### SUBMITTAL SUMMARY REPORT 33243

MCGINLEY TRG MASS GRADING **PLAN NAME:** LOCATION:

OCE: Plan Review (DR) v.1 ITEM REVIEW NAME (DEPARTMENT)

## MASS GRADING PLAN McGINLEY TRG MASS GRADING

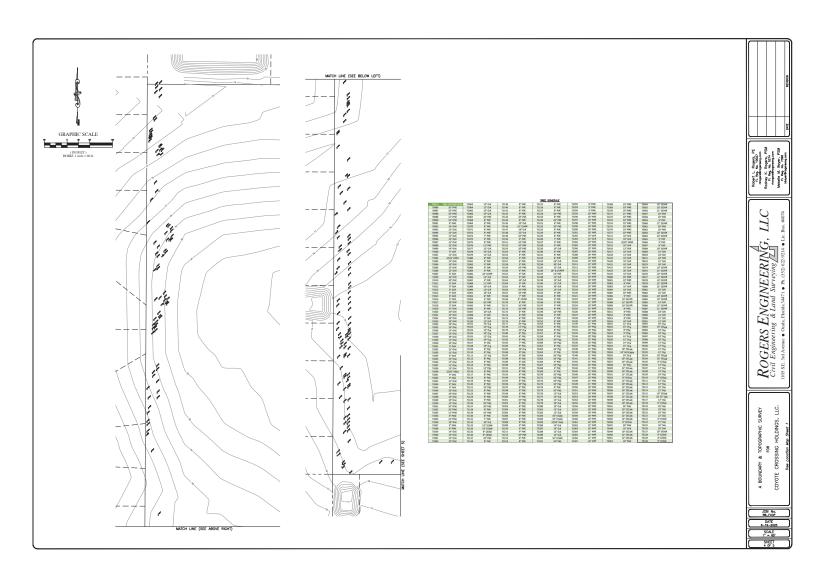
YES 2.12.4.L(2)/3.2.3 - Use Consistent with FLU Designation? Portion of the parcel 41205-001-03 is Public. FLU on cover sheet is

missing the Public. Please correct on cover sheet and label on the plan.

YES 2.12.4.L(3) - All applicable Developer's Agreements listed? Rezoning PUD approval information is missing. Please show

approved rezoning information on the cover sheet.

YES 2.12.32 - Show 100 yr flood zone Include flood zone designation on cover.

YES 5.2 & 5.3 - Verify any overlay zones such as ESOZ, Springs Protection, or Flood Plain Include secondary springs protection zone on cover.
